## ADDENDUM NO. 6

**Project:** Missoula Garden City Compost Improvements Project

**Date of Addendum:** March 24, 2025

**ADDENDUM #6 - EXHIBIT A**

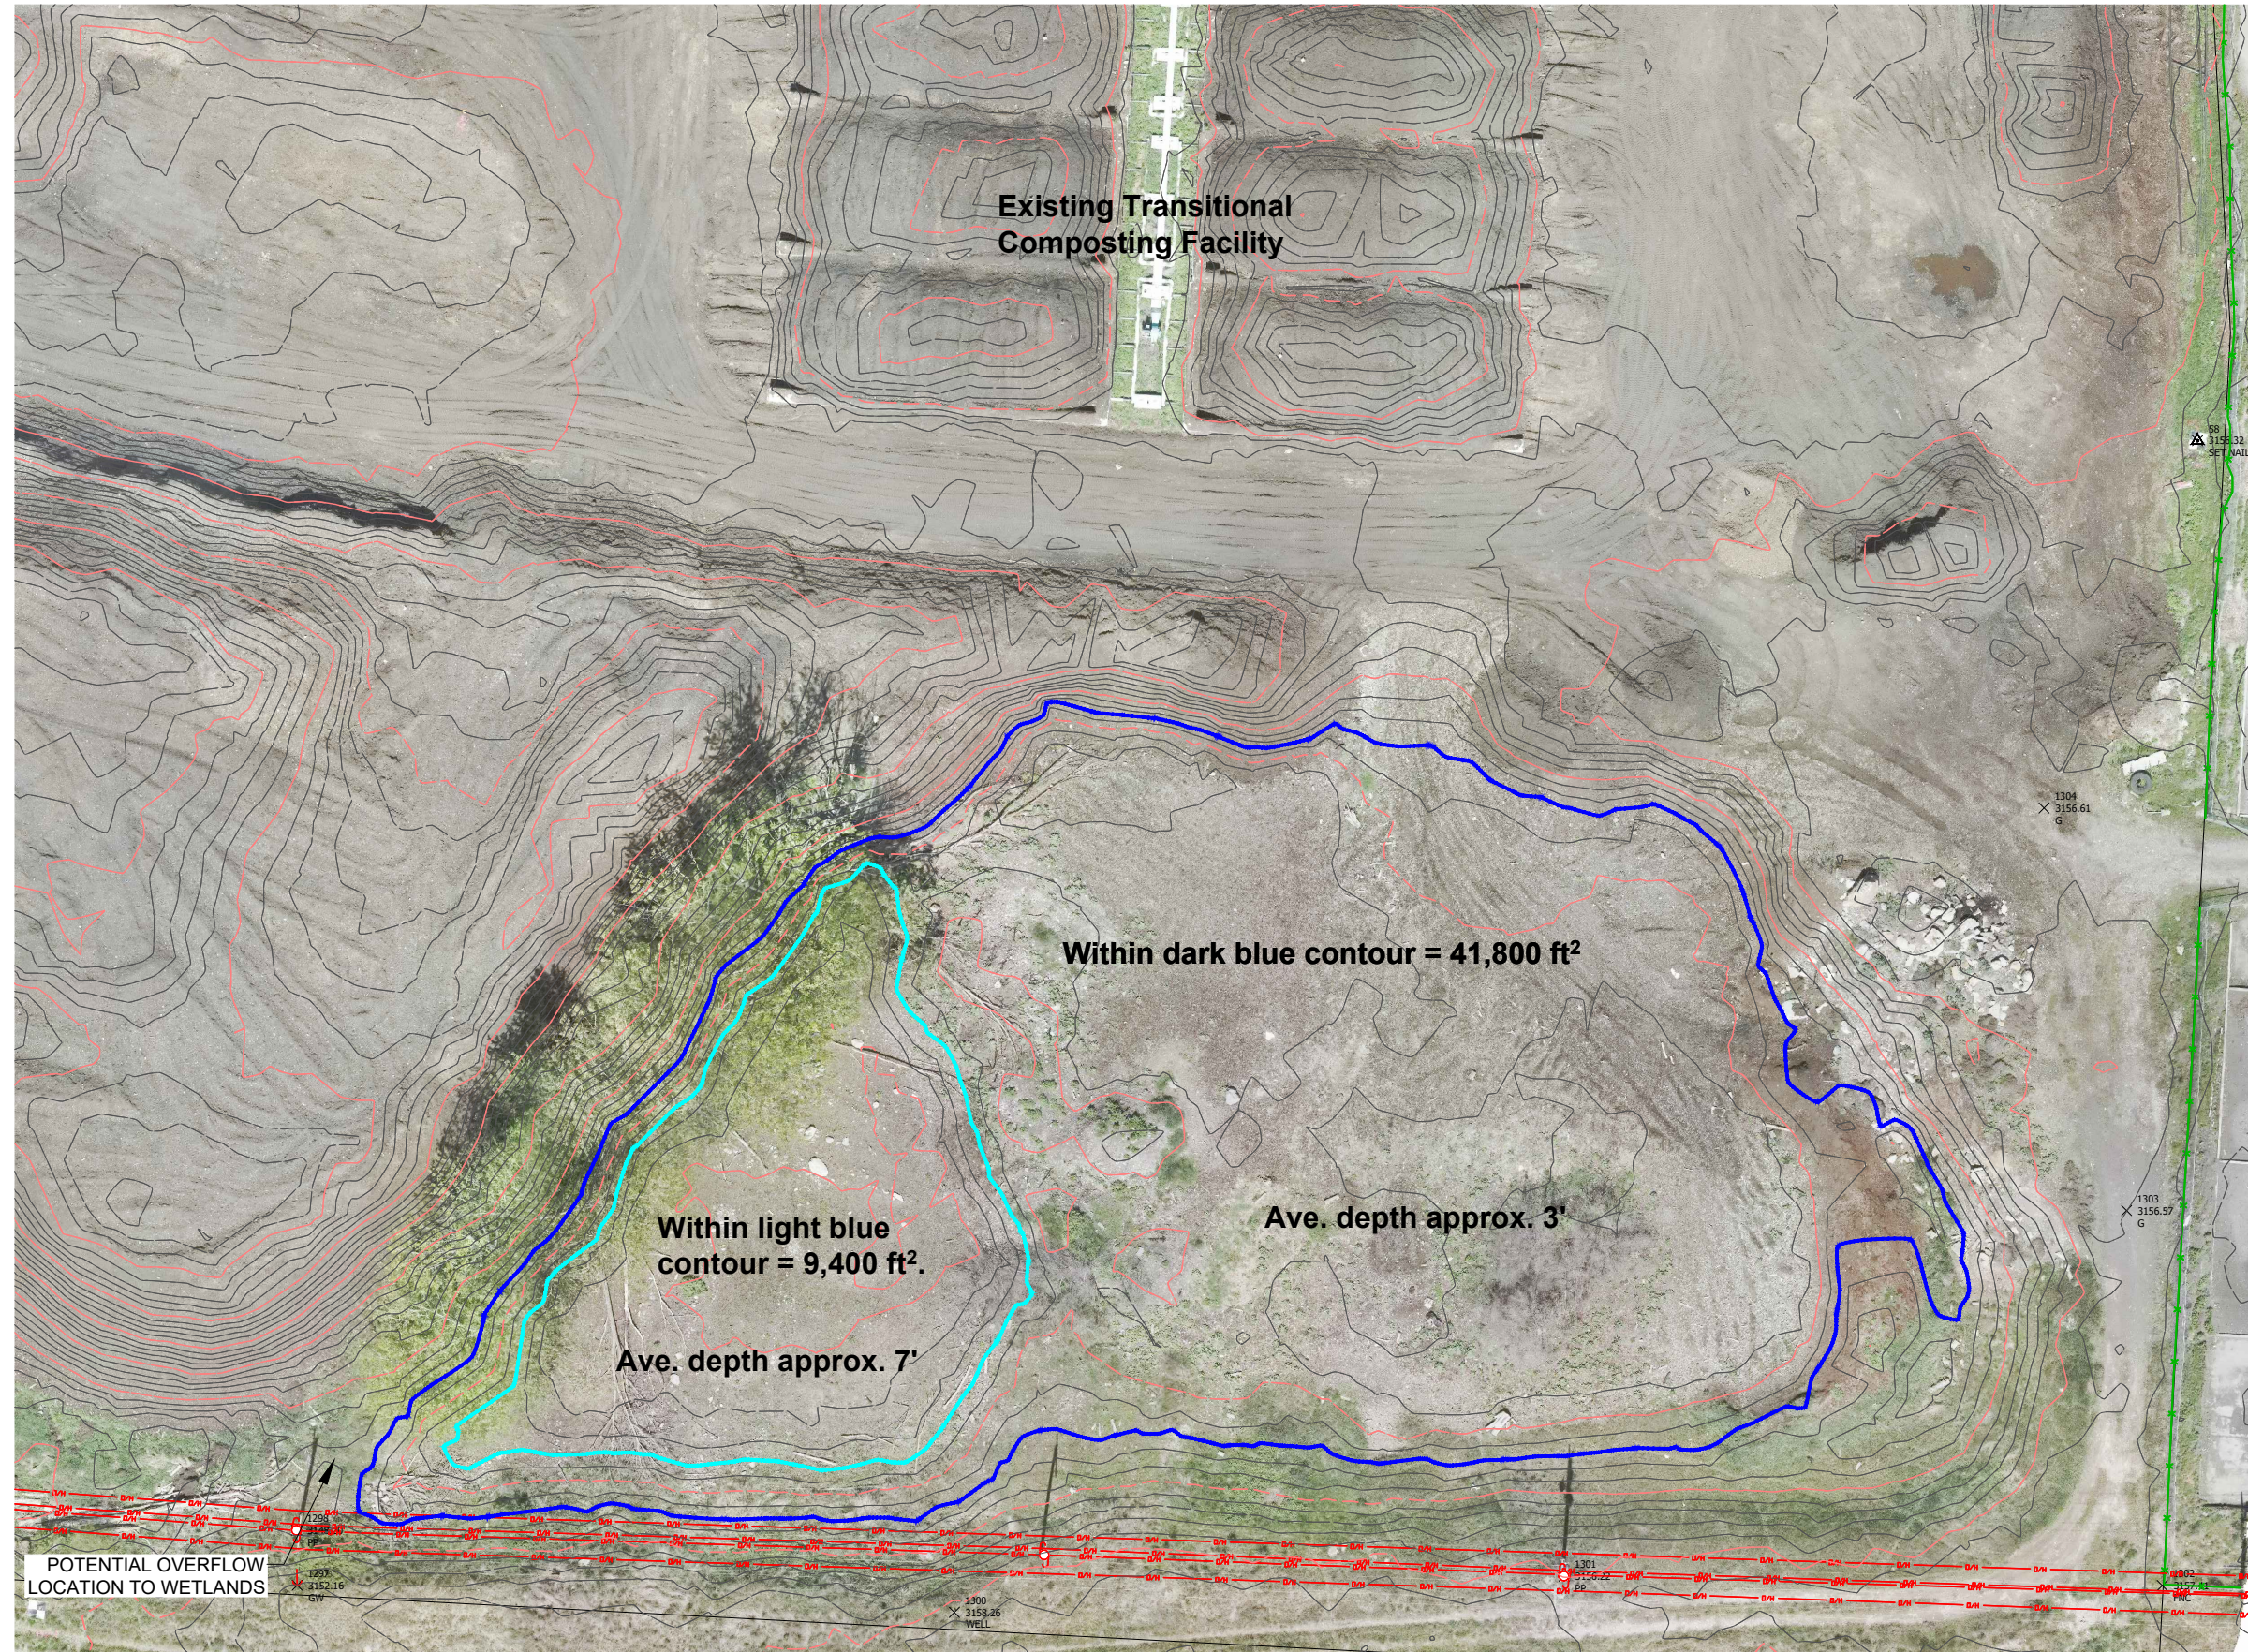
1. MDEQ has stated that the old sludge storage pond south of the project site can be utilized for the disposal of construction dewatering effluent under the following condition: the pond must first be re-contoured to eliminate the risk of surface overflow to the Clark Fork or adjacent delineated wetlands. Presuming there is no discharge to State waters, an authorization under General Permit MTG-070000 for Construction Dewatering is not required. Please see Exhibit A for a plan sheet showing the location and size of the existing sludge storage pond.
